# Access Compliance Report

## Public Rights-of-Way

### (Curb Ramps)

Intersection ID: 17274	Main Street: MONROE_RD	Cross Street: VISTA_DR	Location: NE
ADA ID: FCAA8EA28F46	Ramp Type: Directional1	Initial Pass/Fail: Fail	Overall Compliance: No
Severity Score: 12.5			
Codes/Mitigation Info/Possible Solution		Field Measurements/Component Compliance

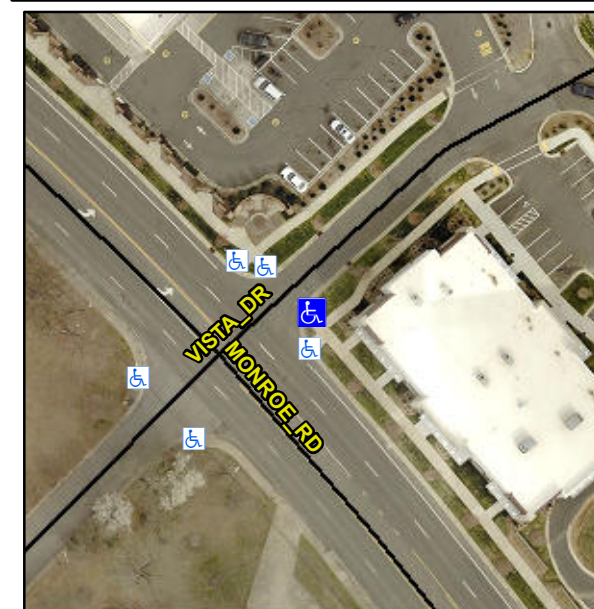
**R304.2.2**

Compliance	Description	Data	Compliance	Description	Data
N/A	Ramp Length (in)	78.0	N/A	Grade Break?	N/A
Yes	Ramp Width (in)	69.0	N/A	Grade Break Slope (%)	0.0
No	Ramp Slope (%)	9.0	N/A	Grade Break XSlope (%)	0.0
Yes	Ramp XSlope (%)	1.1			
N/A	Flare Type LT	N/A	N/A	Flare Type RT	N/A
N/A	Flare Slope LT (%)	N/A	N/A	Flare Slope RT (%)	0.0
N/A	Flare Traversable LT?	N/A	N/A	Flare Traversable RT?	N/A
N/A	Landing Length (in)	0.0	N/A	DWS Provided?	N/A
N/A	Landing Width (in)	0.0	N/A	DWS Contrast?	N/A
N/A	Landing Slope (%)	0.0	N/A	DWS Length (in)	N/A
N/A	Landing X Slope (%)	0.0	N/A	DWS Full Width?	N/A
N/A	Landing Curb? (Y/N)	N/A	N/A	DWS Offset LT (in)	N/A
N/A	Shared Landing?	N/A	N/A	DWS Offset RT (in)	N/A
N/A	Gutter Ponding?	0.0	N/A	Gutter Slope (%)	N/A
N/A	Gutter Lip Ht (in)	0.0	N/A	Gutter X Slope (%)	N/A
N/A	Painted X Walk1?	No		Road Slope (%)	0.8
	X Walk 1 Direction	To NW		Road X Slope (%)	0.8
	X Walk 1 Width (in)	N/A		Clear Space?	N/A

**Remove & Replace Entire Ramp.**
